KITSAP COUNTY DEPARTMENT OF PUBLIC WORKS STORMWATER NO. 97003141

SUQUAMISH REGIONAL STORMWATER TREATMENT FACILITY

ADDENDUM # 1

Questions & Answers – March 07, 2025 Attachment to ADDENDUM # 1

Figure 1 – NOAA Tide Predictions Plot for Tuesday, March 4, 2025.

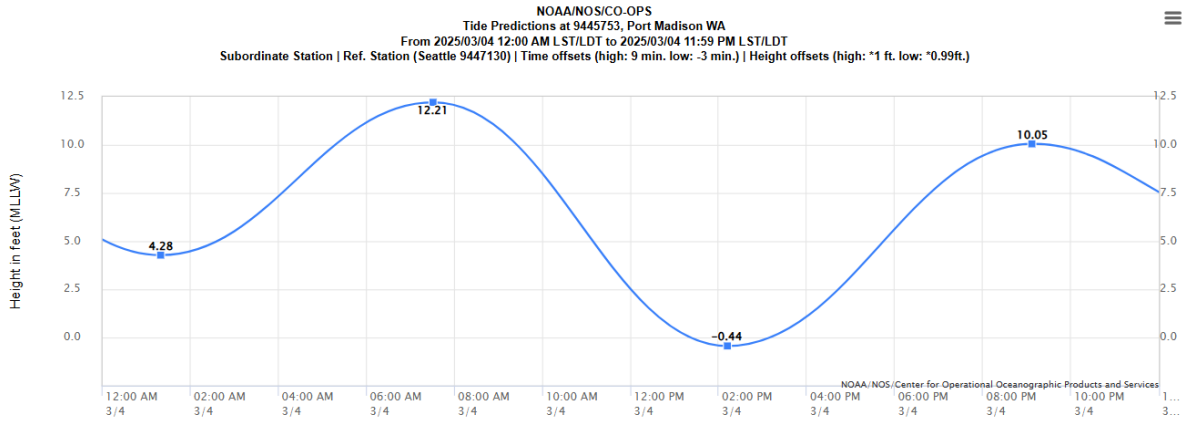
Question: What is the current water elevation?

Answer: *Based on NOAA Tide Predictions' historical data, the tidal elevation was approximately 8.5 ft (MLLW) at the start of the pre-bid meeting (Port Madison Station 9445753). See Figure 1 below.*
